Details of Enquiry:

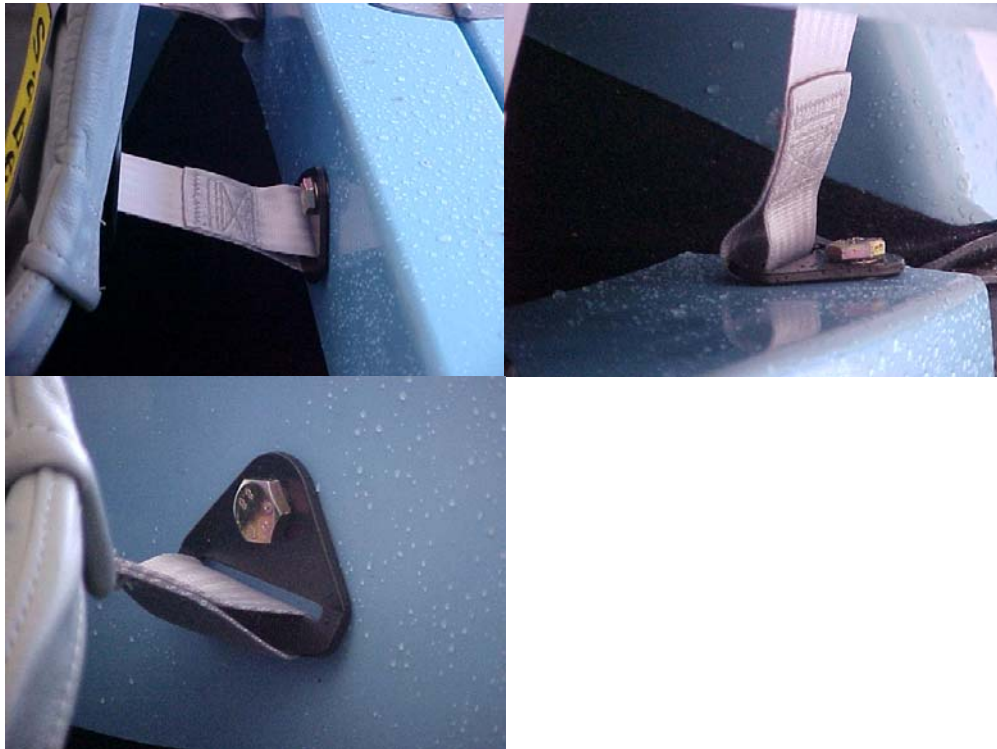
The upper seat belt mounting brackets on a Kit car are fixed into the rear bulkhead, (See photos) and the seat belt direction of pull is 90 degrees to the bulk head instead of in the natural direction of pull for these brackets. Are these acceptable?

Yes.

In respect of the bolt and loop bracket direction of pull only, bending of the bracket may occur but neither the bolt (assuming the correct seat belt bolt) or bracket is likely to fail under the Directive Test.

The vehicle structure continues to require a full assessment.
